**Before the
FEDERAL COMMUNICATIONS COMMISSION
Washington, D.C. 20554**

Applications of)	
)	
SPACE EXPLORATION HOLDINGS, LLC)	Call Signs S2983 and S3018
)	
)	File No. SAT-MOD-20200417-00037
For Modification of Authorization for the)	
SpaceX NGSO Satellite System)

**PETITION TO DENY OR DEFER
OF VIASAT, INC.**

July 13, 2020

Figure 1: SpaceX EPFD down 17.8 GHz, 40 kHz, 1m FSS¹¹²

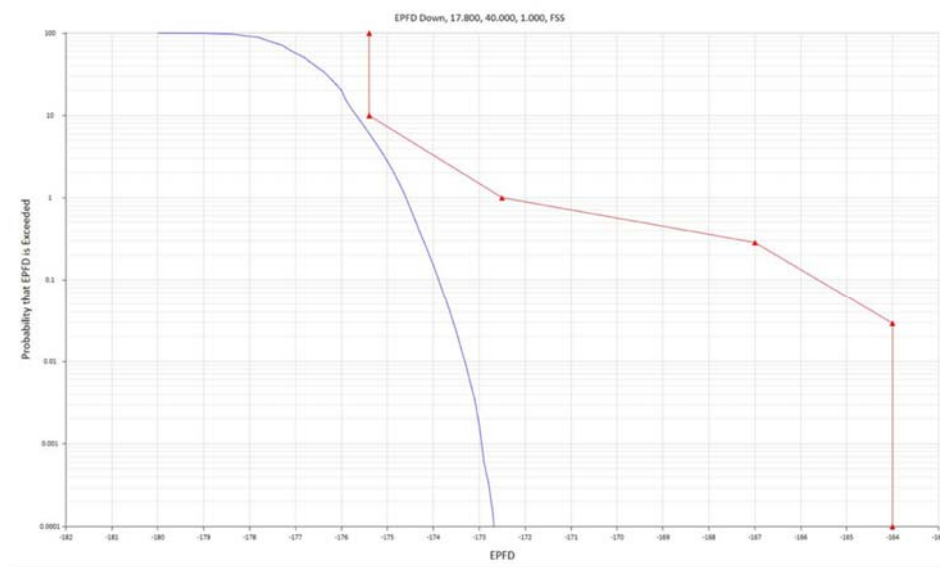
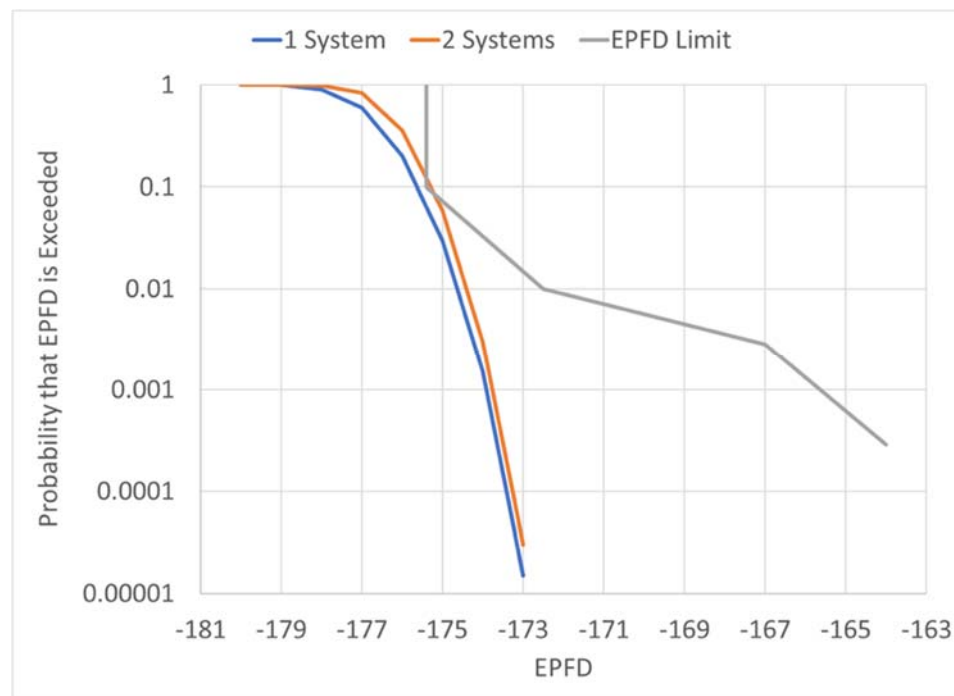
Clarifying this issue is critical to determining EPFD compliance. To illustrate the concern, consider the aggregate EPFD implications should only two separate SpaceX ITU filings (USASAT-NGSO-3B-R and STEAM-2) be brought into use, each in accordance with the technical parameters specified in the modification application.¹¹¹ Even assuming that the system described in each filing operates cooperatively to avoid mutual interference, the EPFD level increases to the point where the combined system would no longer fit within the Article 22 single-entry limits. Figures 1-4 below illustrate the concern. While these examples are for Ka-band downlink EPFD with a specific reference antenna, operating a NGSO system under multiple ITU filings is a concern in all bands and directions, and under all reference parameters.

This initial analysis should be further expanded to consider the aggregate EPFD implications from the recent filings for 30,000 satellites made on SpaceX's behalf at the ITU in October 2019. If that analysis were undertaken, it may become even more evident why SpaceX

should provide further technical analysis to demonstrate how it intends to attain EPFD compliance with ITU single entry EPFD limits for the Starlink system in accordance with ITU Radio Regulations and the Commission's requirements.

Figure A1-3. Downlink Comparison for Various Telesat Antennas at 75°N (Ka-band)

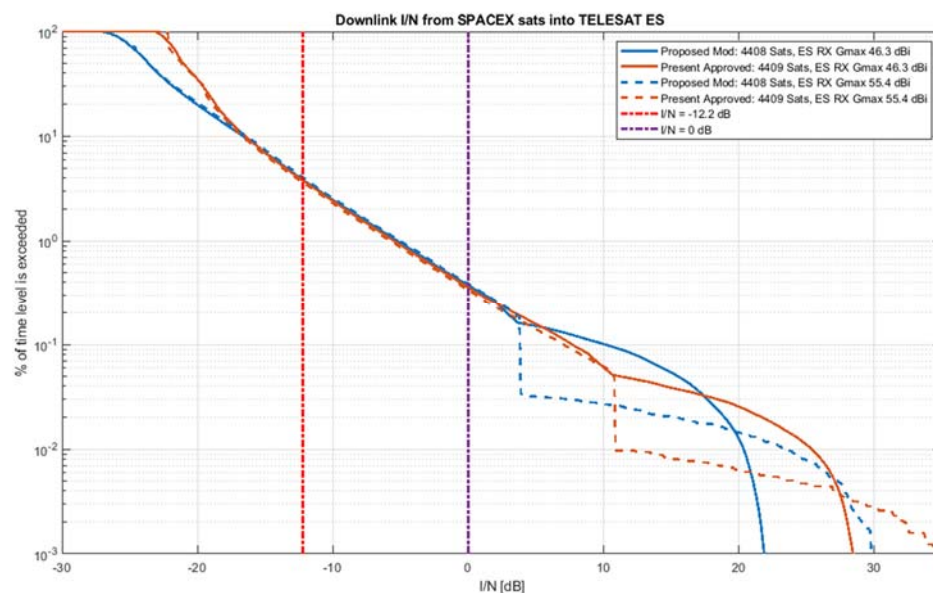
SpaceX compares before (pre-mod) and after (post-mod) I/N CDF curves to demonstrate that the proposed modification does not increase interference, stating that “the new interference levels resulting with the modification are mostly less than (and at worst equal to) the interference levels that would have been experienced with the current constellation in the noise-dominated environment (*i.e.*, $I/N \leq 0$ dB).”¹¹⁶

If this actually were the case, it would show that interference into other NGSO systems from the prior processing rounds has not increased. However, it appears that Figure A1-3. Downlink Comparison for Various Telesat Antennas at 75°N (Ka-band) shows the opposite: in fact, interference would increase for the 55.4 dBi Telesat antenna.¹¹⁷ This also appears to be the case in SpaceX’s Figure A1-11. Uplink Comparison for Various O3B Antennas at 35°N (Ka-band), this time for the 45 dBi O3B antenna.¹¹⁸

These figures from the modification application suggest that the proposed modification may result in some exceedances, but it is difficult to tell if that is just a result of the granularity of the figures provided. Therefore, Viasat requests that the Commission require SpaceX to file a table, similar to what Viasat provided in its recent modification application.¹¹⁹
